ADDENDUM No. 3

**ORG #207 – San Jacinto Elementary School - Renovation
ORG #273 – Pleasant Grove Elementary School – Renovation**

DALLAS INDEPENDENT SCHOOL DISTRICT

11/01/2024

ENLARGED PLANS, DOOR SCHEDULES, DETAILS, & FINISHES

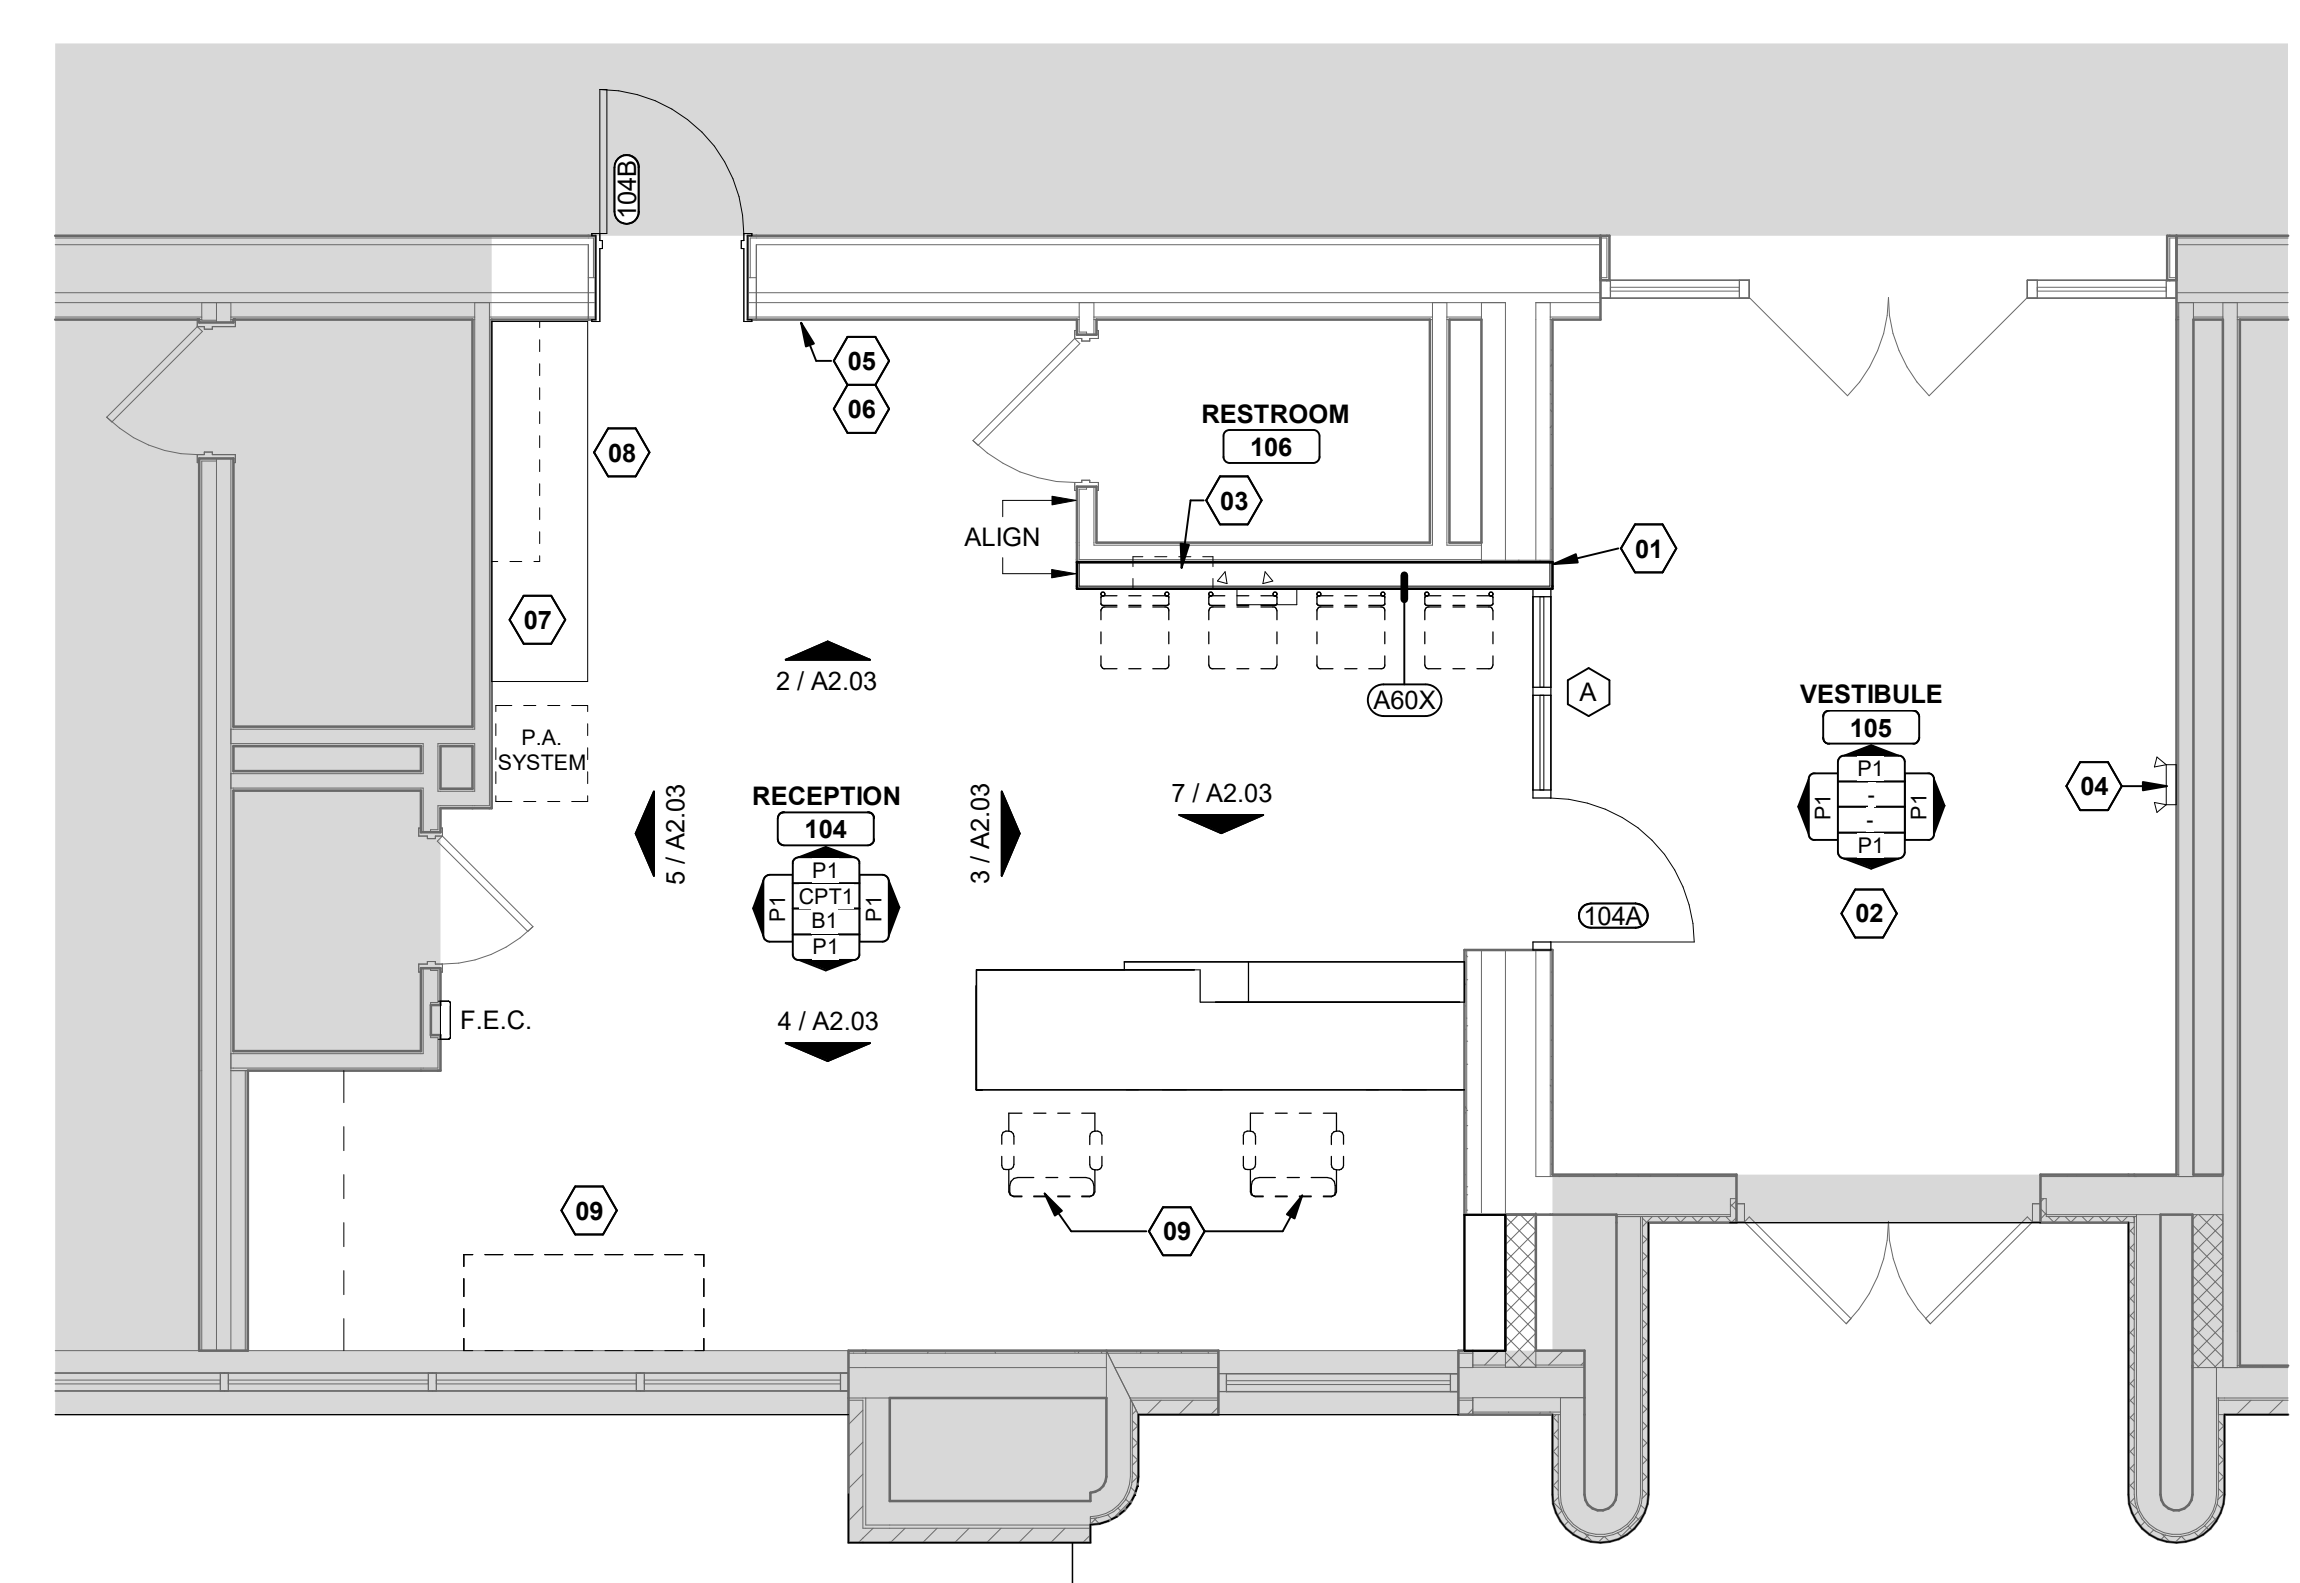
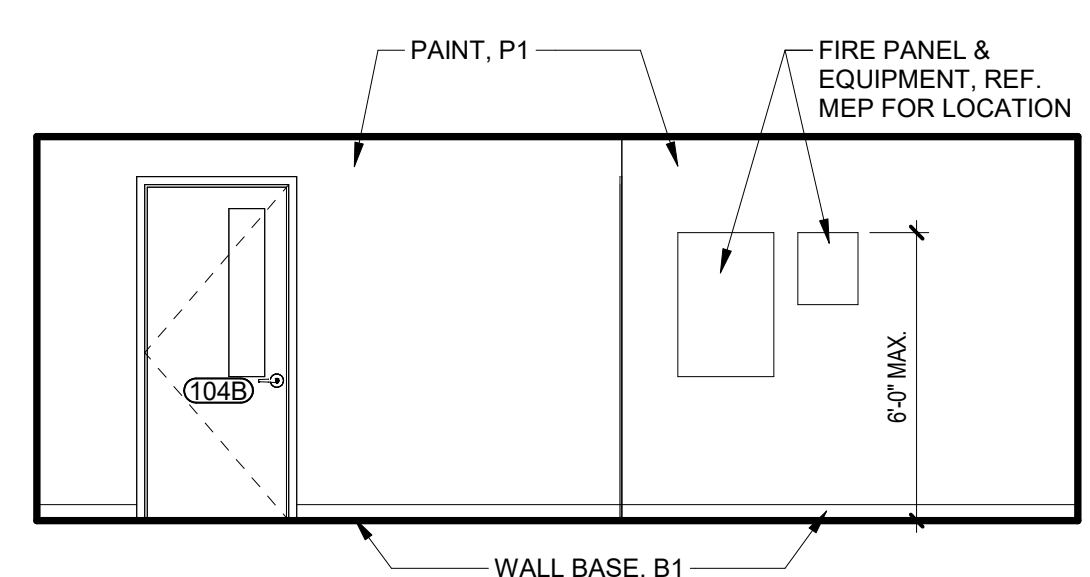
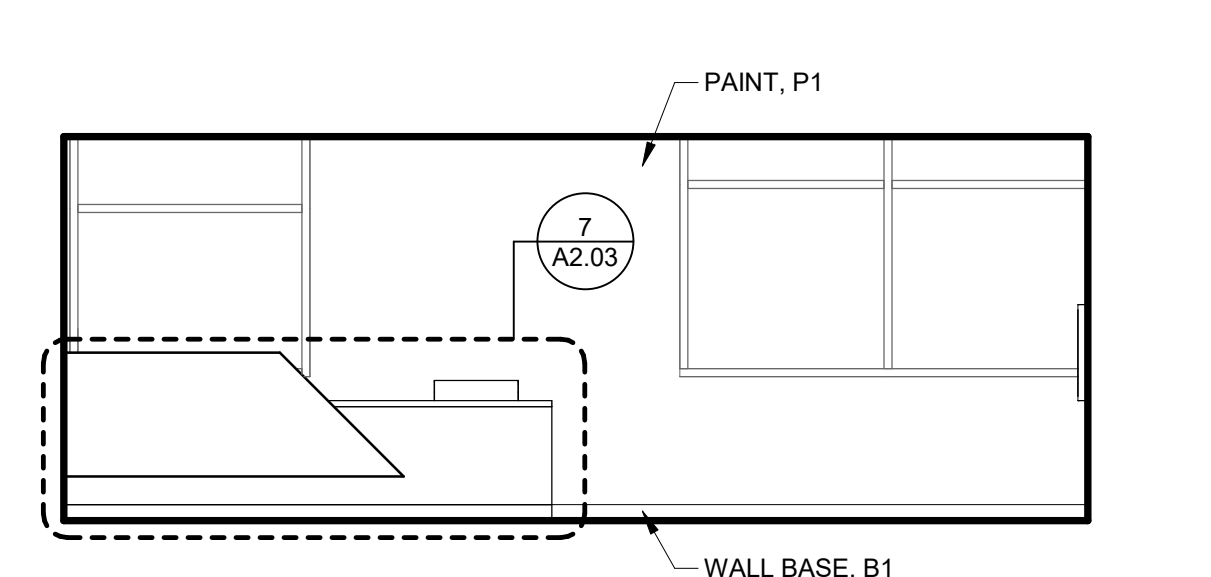
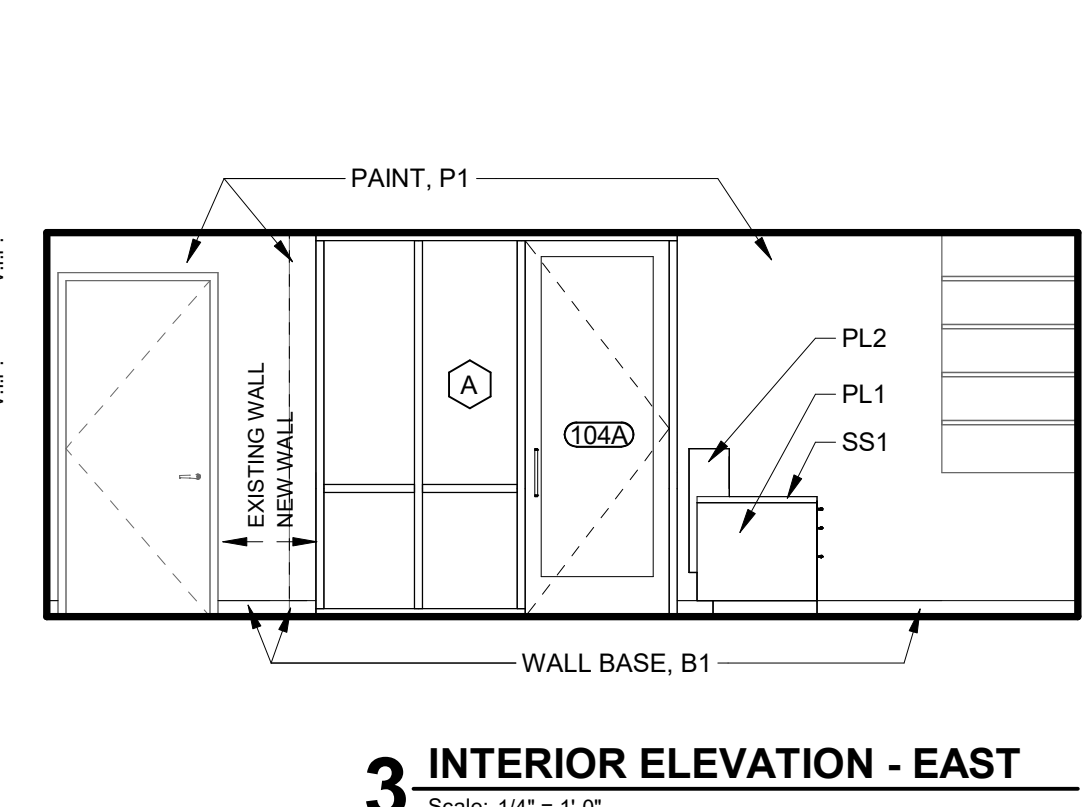
- Replace sheet with the revised attached A2.03.
 - Carpet to be Mohawk Datum in color Basalt as indicated.
- Replace sheet with the revised attached A0.02 and A0.01.

ENLARGED DEMOLITION PLANS

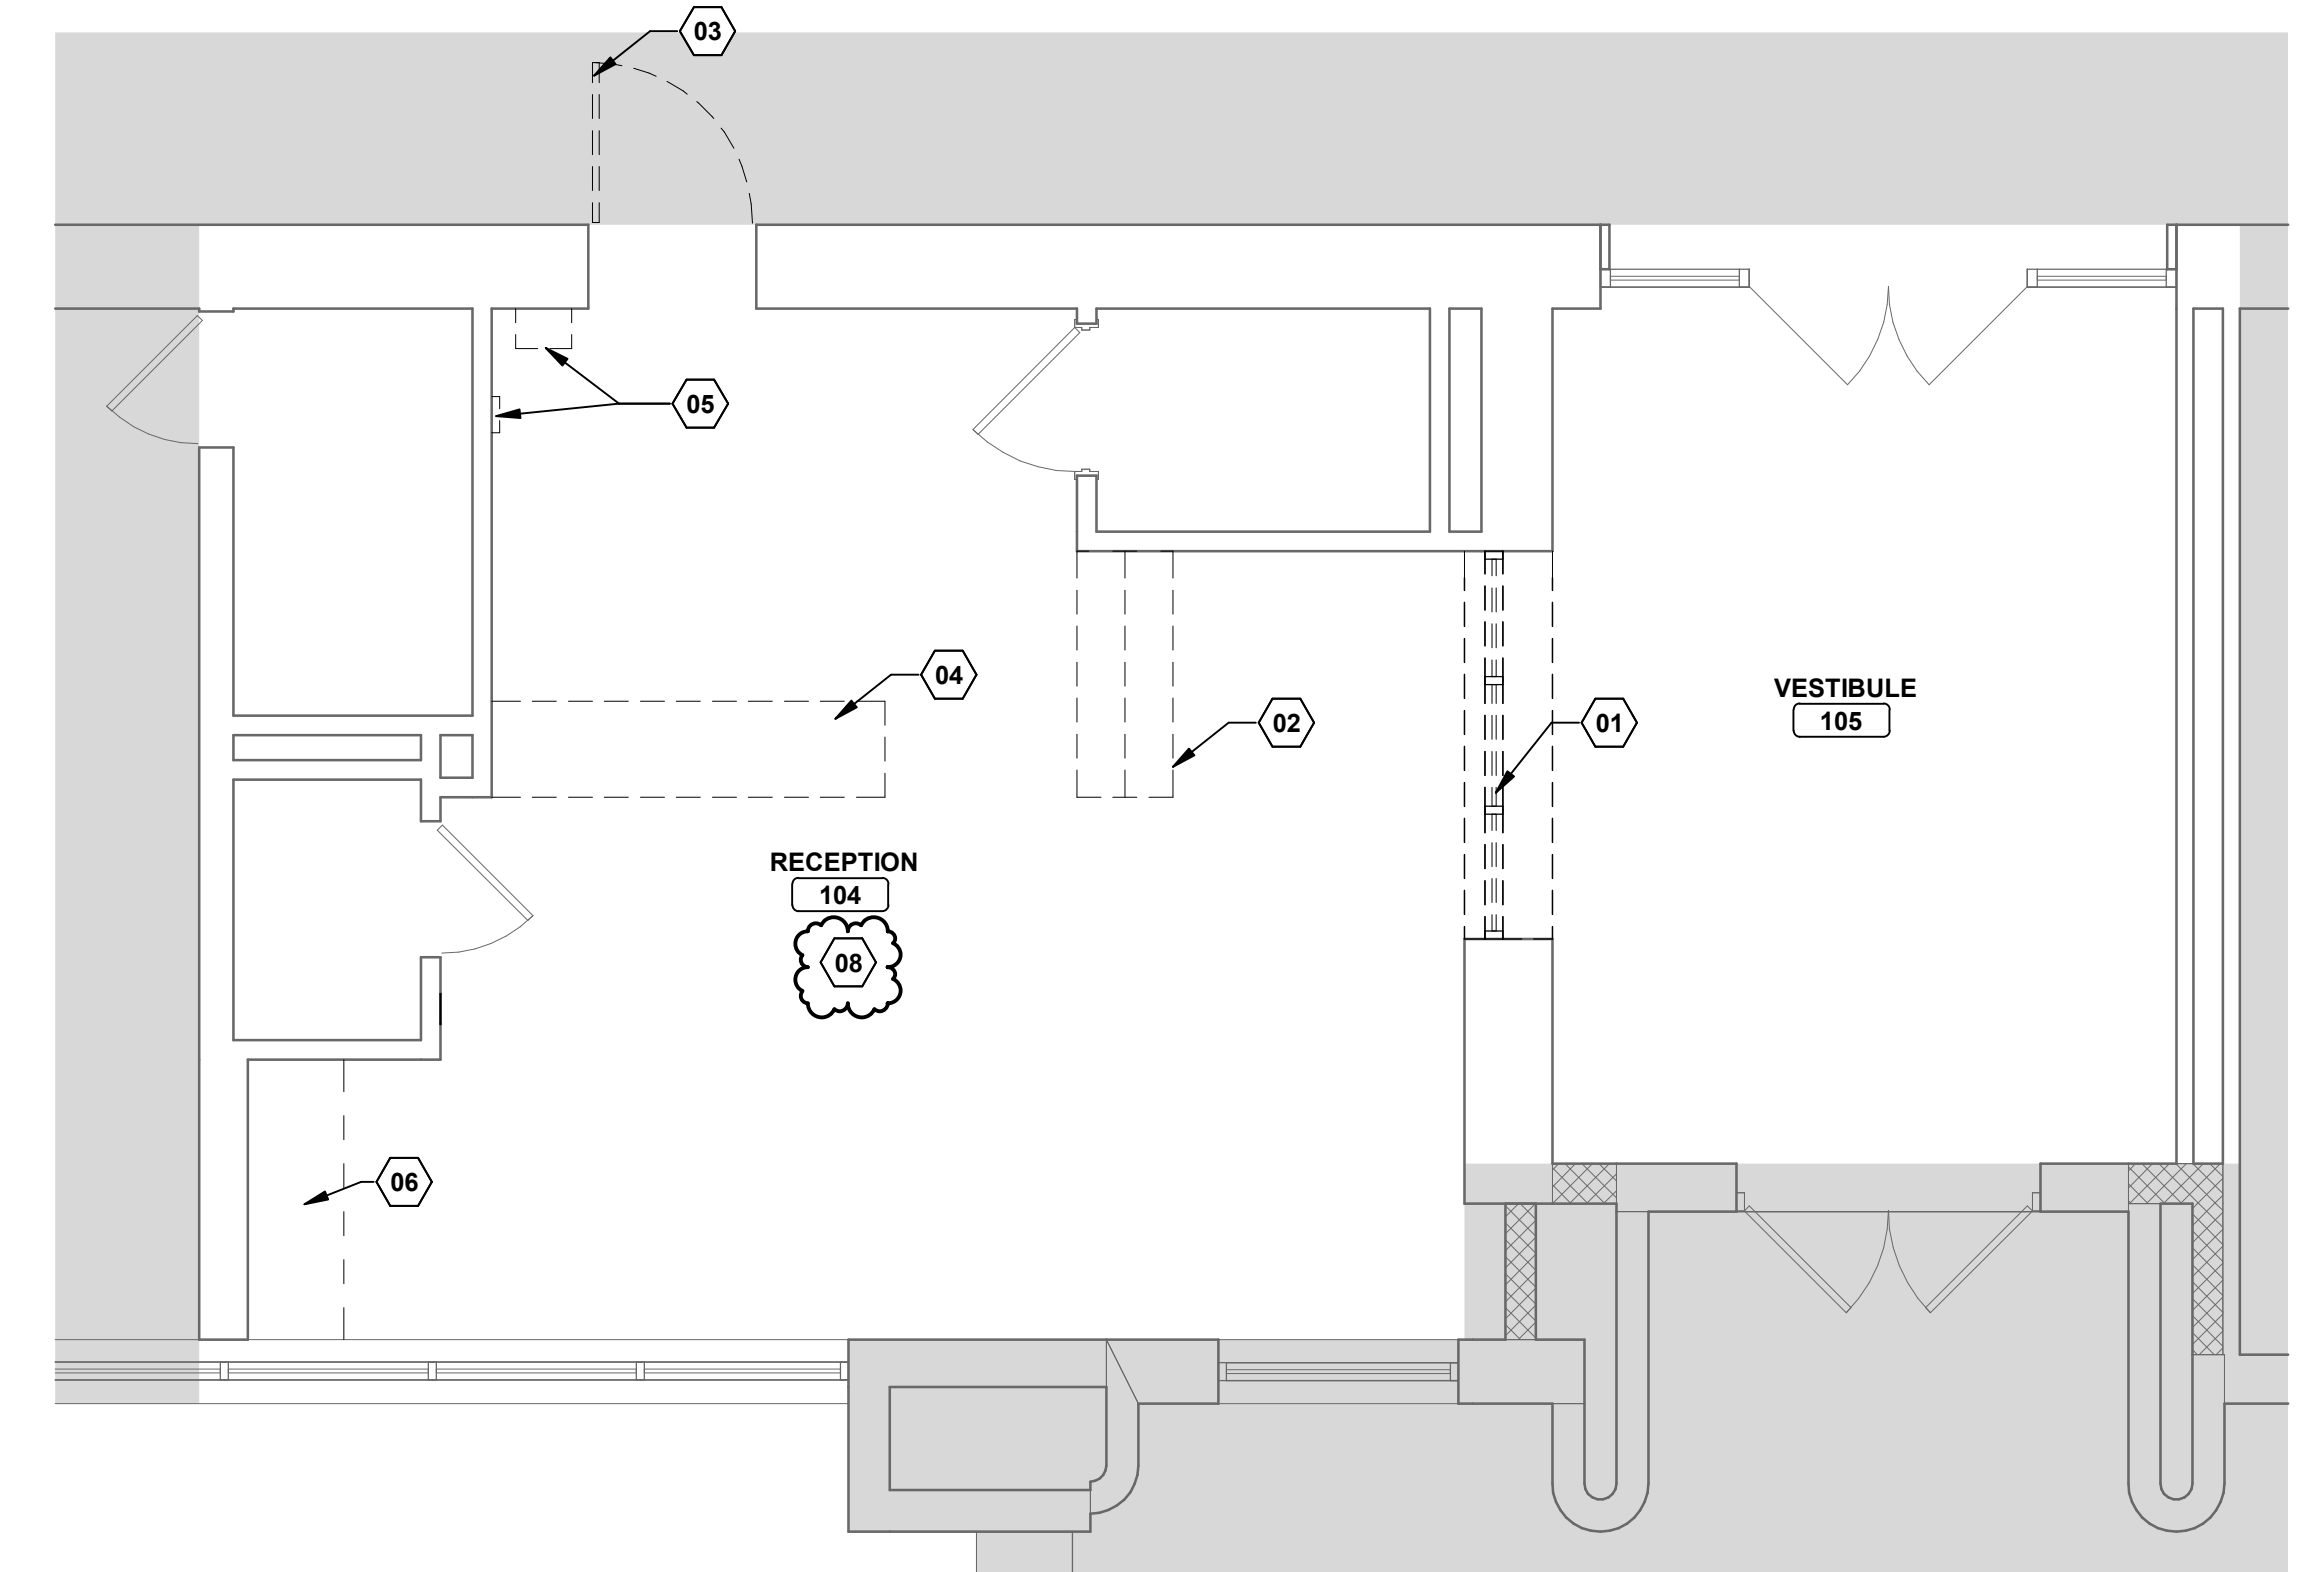
- Note added: “Removal / reinstallation of existing WAPs must be coordinated with DISD IT at least 2 weeks in advance.”
- Replace sheet with the revised attached A1.01.

- 01 REMOVE AND DISCARD PORTION OF EXISTING WALL AND PASS THRU WINDOW, PREP OPENING TO RECEIVE NEW STOREFRONT, PATCH AS NEEDED.
- 02 REMOVE MILLWORK AND SAVE FOR RELOCATION
- 03 DOOR, HARDWARE AND FRAME TO BE REMOVED PREP. FOR A NEW DOOR WITH ELECTRIFIED HARDWARE
- 04 REMOVE MILLWORK AND SAVE FOR POSSIBLE RELOCATION COORDINATE WITH OWNER
- 05 REMOVE THERMOSTAT AND CHECK-IN DEVICE SAVE FOR RELOCATION, REF. MEP
- 06 EXISTING MILLWORK TO REMAIN, PROTECT DURING CONSTRUCTION.
- 07 DOOR TO BE REMOVED PREP. FOR A NEW DOOR WITH ELECTRIFIED HARDWARE FRAME AND STOREFRONT TO REMAIN.
- 08 REMOVAL / REINSTALLATION OF EXISTING WAPS MUST BE COORDINATED WITH DISD IT AT LEAST 2 WEEKS IN ADVANCE.
